VPCH Office Expansion  
155 Queen St N  
Hamilton, ON L8R 2V6

**Construction Tender**  
**ARCHITECTURAL ADDENDUM**  
**No. 03**

Friday, October 06, 2023

1 WALL SECTION - SOUTH EXTERIOR WALL AT RIBBON WINDOW

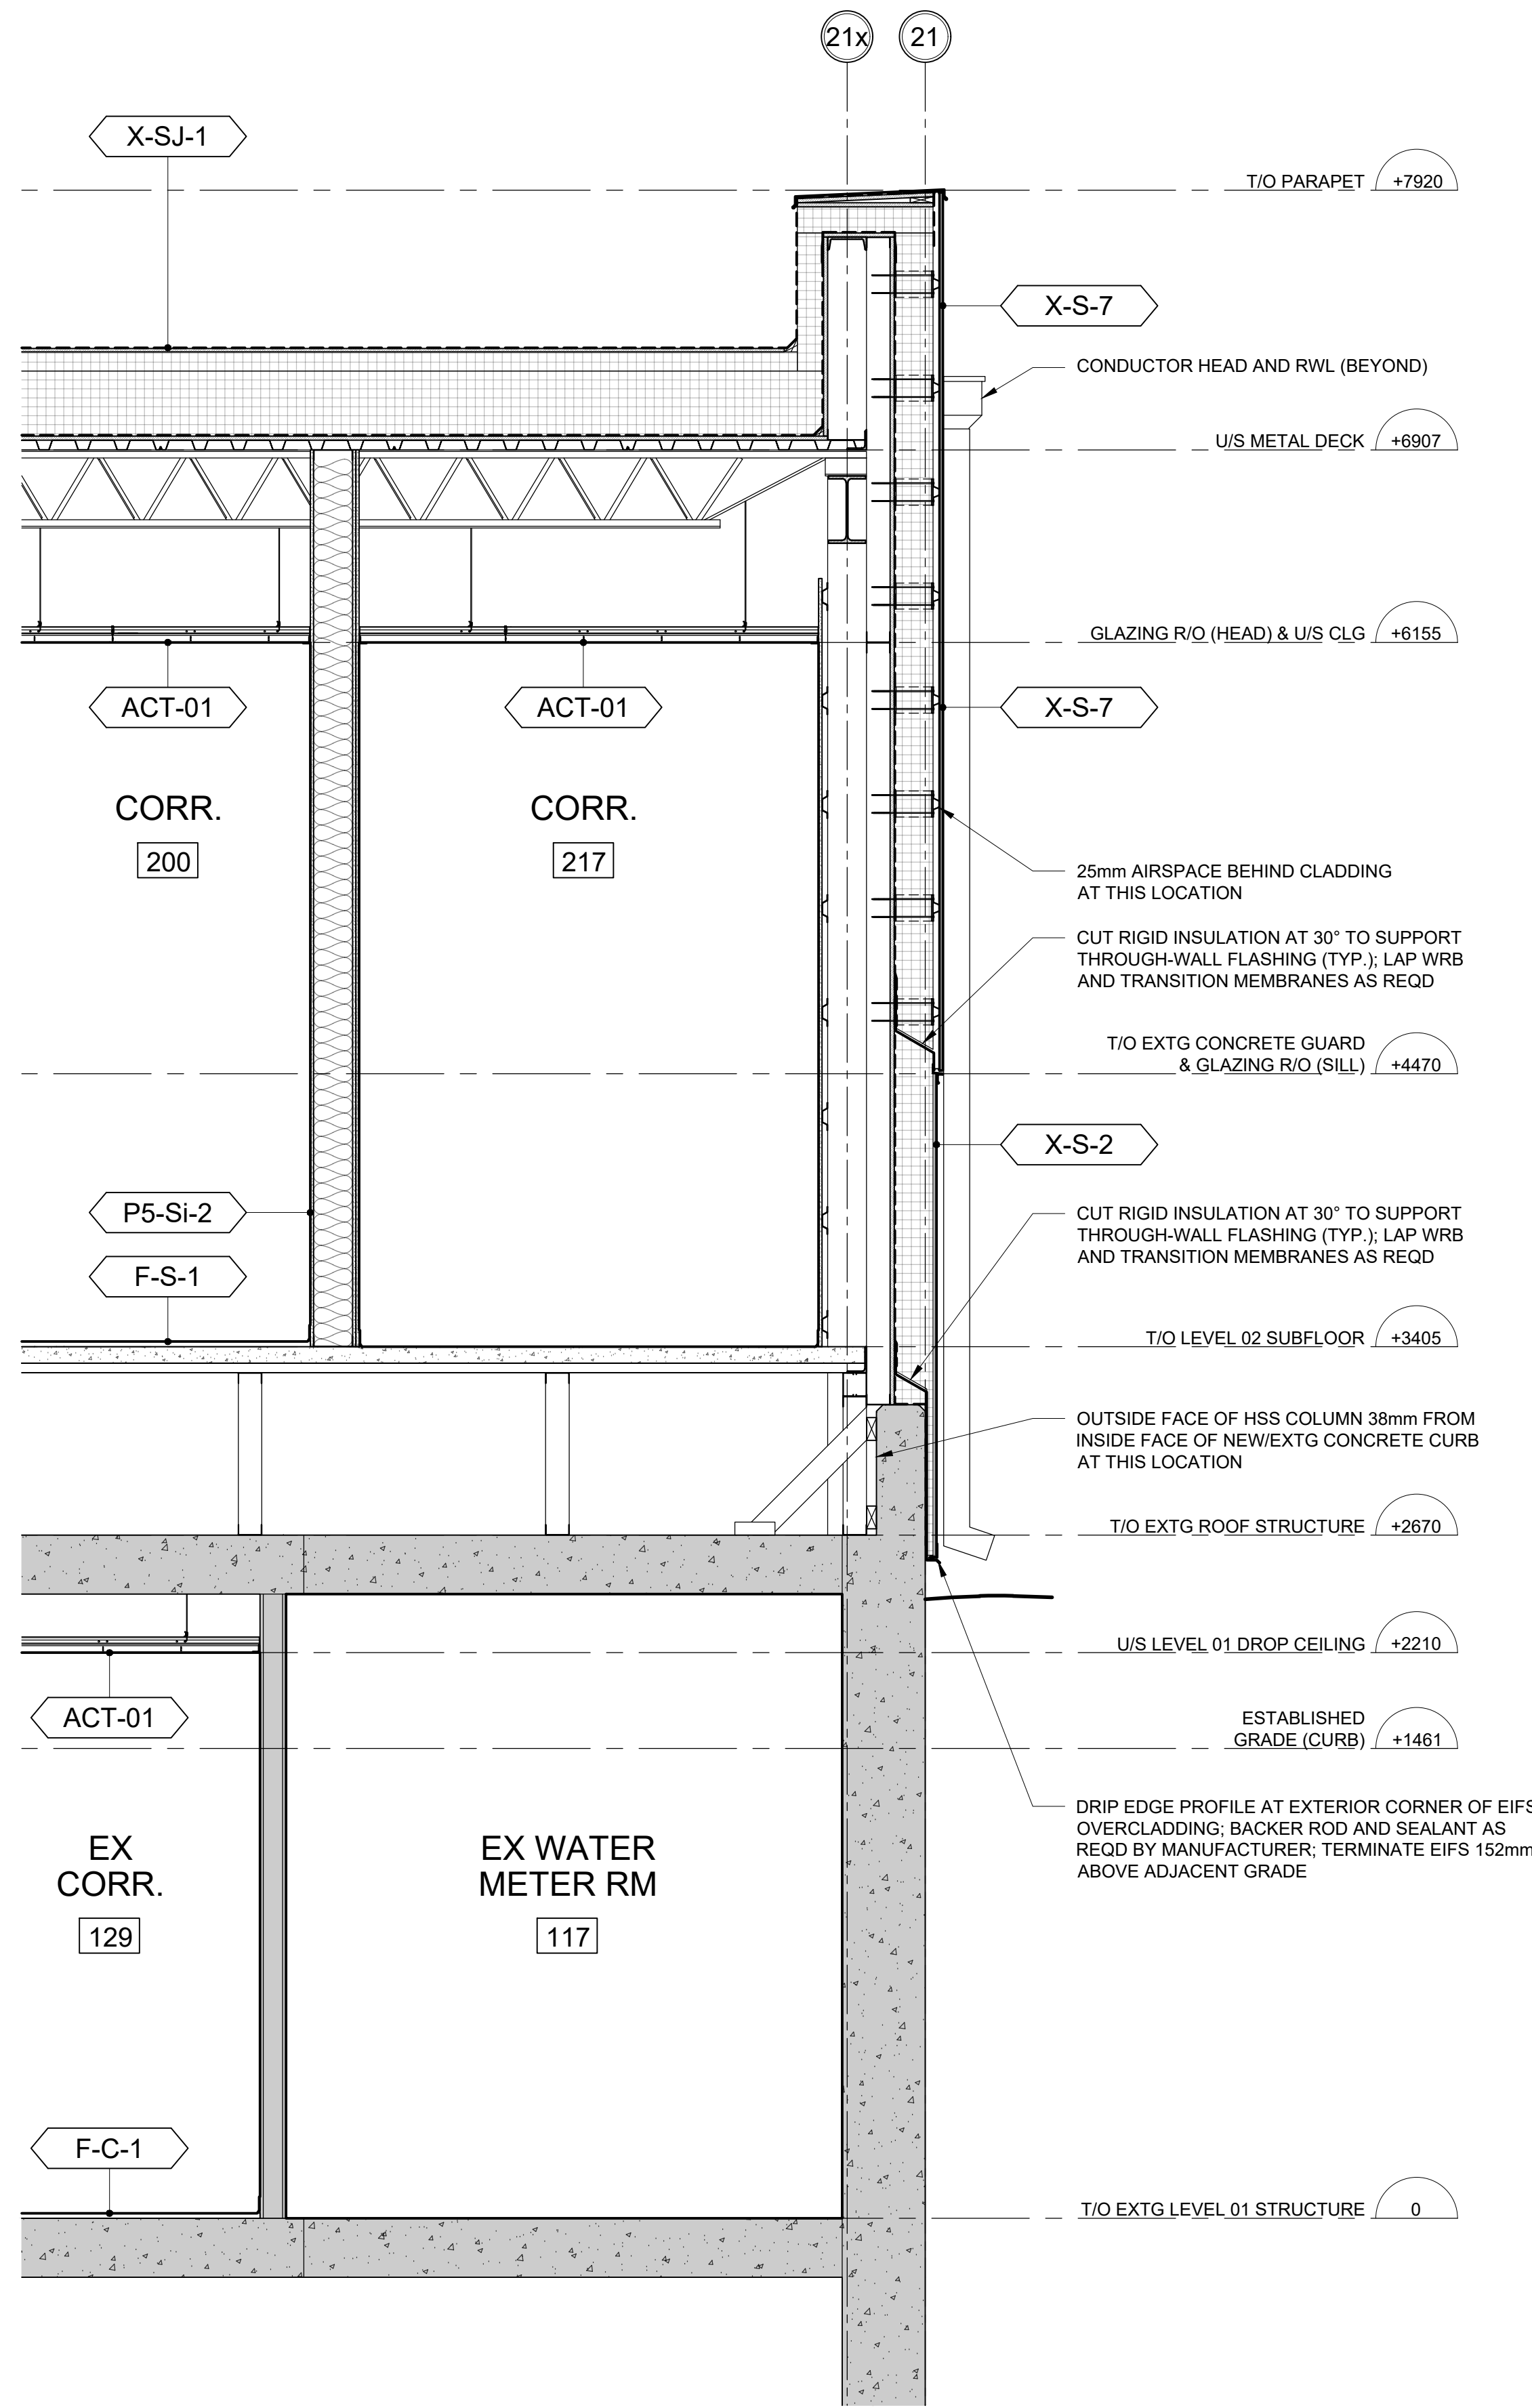
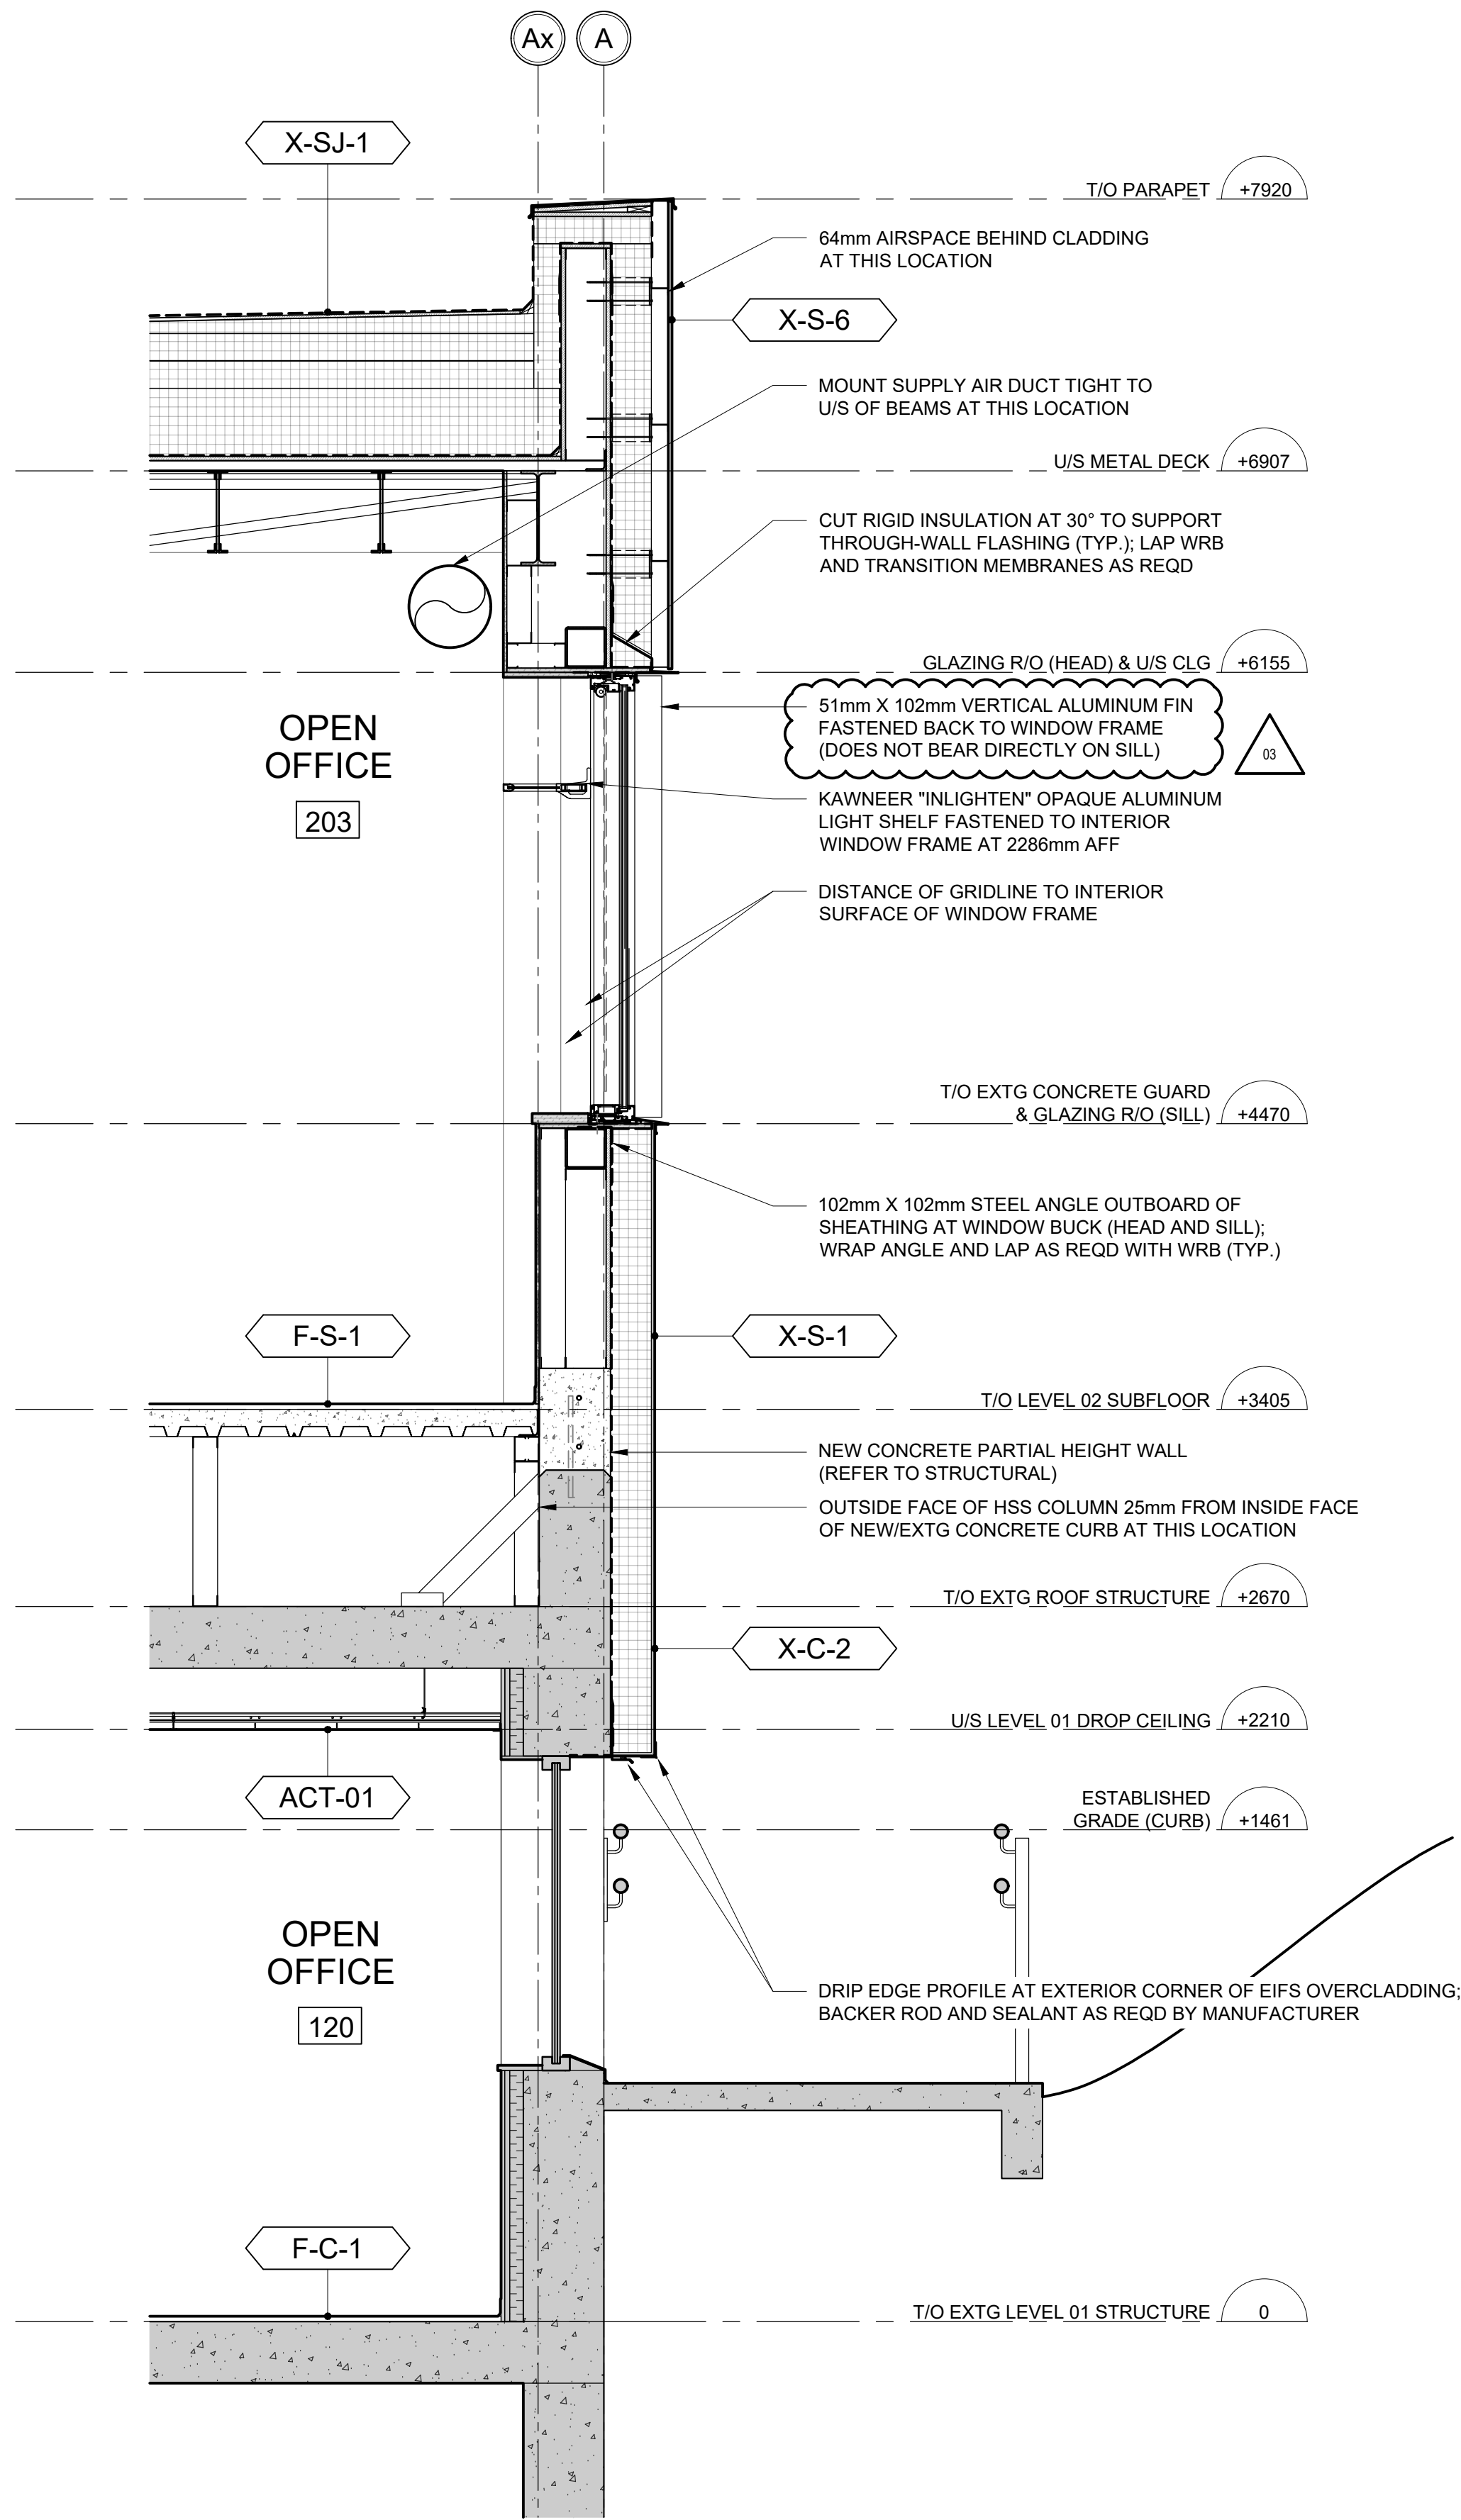
- Response:**  
*Specification section has been included as part of this addendum.*
- 43 **Question:**  
*The specification lists 12 26 00 Interior Daylighting devices, I have not been able to find this on the drawings. Please advise if this item will be required.*

- Response:**  
*Yes this will be required at Room 203 Open Office. Refer to Wall section detail A04.03.*
- 44 **Question:**  
*Door schedule lists doors #F120 Type C, FG205.1 Type D, FG205.2 Type D, F217.3 Type E as paint grade wood doors, but elevations for types C, D & E indicates metal doors, please clarify which is required?*
